SIERRA PACIFIC POWER COMPANY HIRSCHDALE POWER LINE PROJECT

Final Mitigated Negative Declaration
(A.06-04-017)

**Subject: NOTICE OF AVAILABILITY OF A FINAL MITIGATED NEGATIVE DECLARATION
Sierra Pacific Power Company's Hirschdale Power Line Project (A.06-04-017)
SCH# 2007022078**

Photo 2

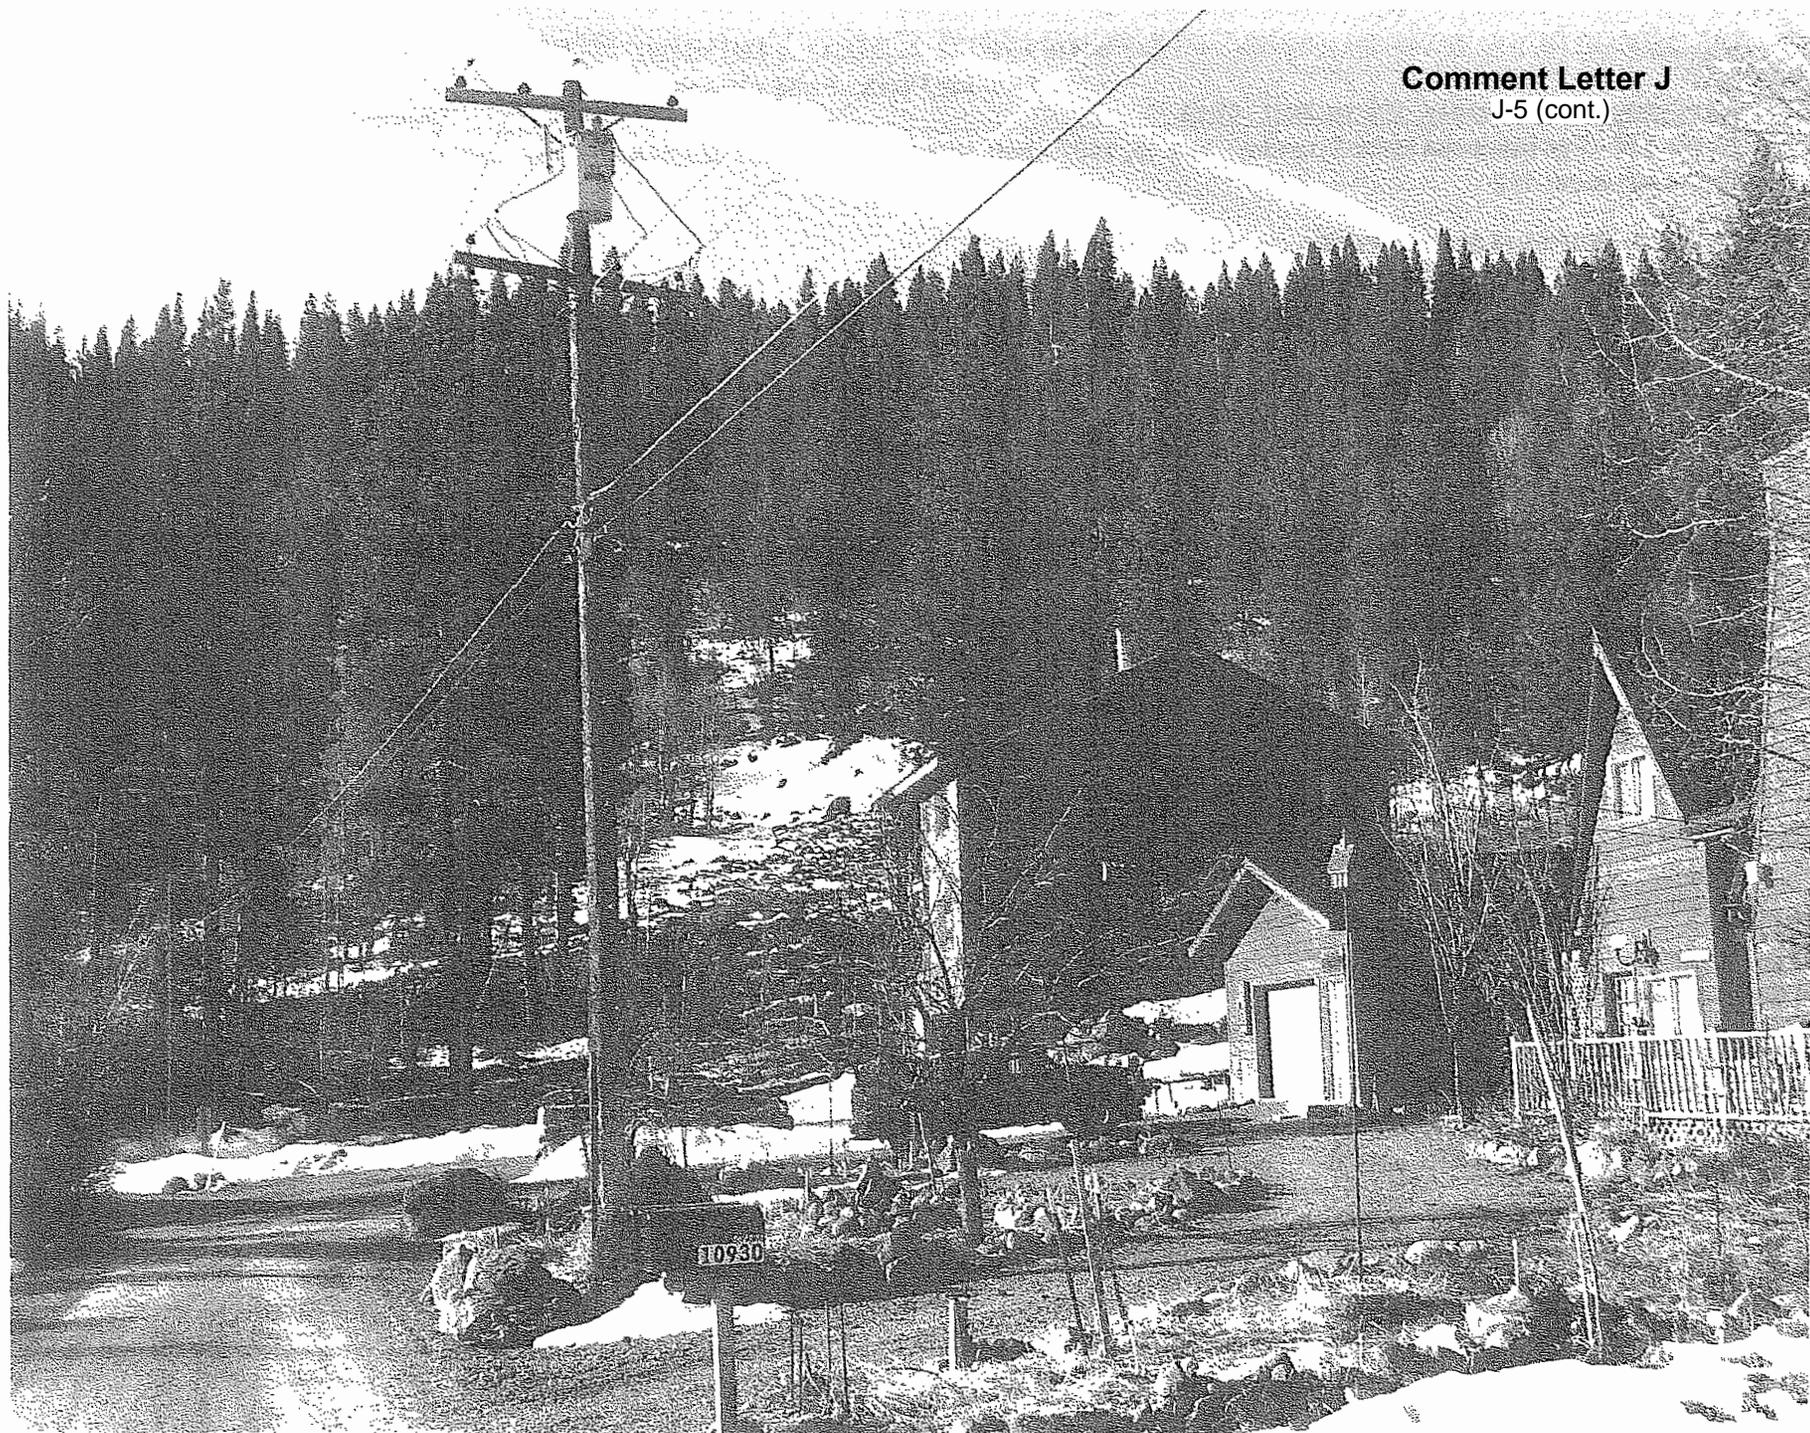
- Photo's 2 and 3 show our quite community. This project definitely has a negative impact of all the homeowners, ~~and~~ residents, and visitors.
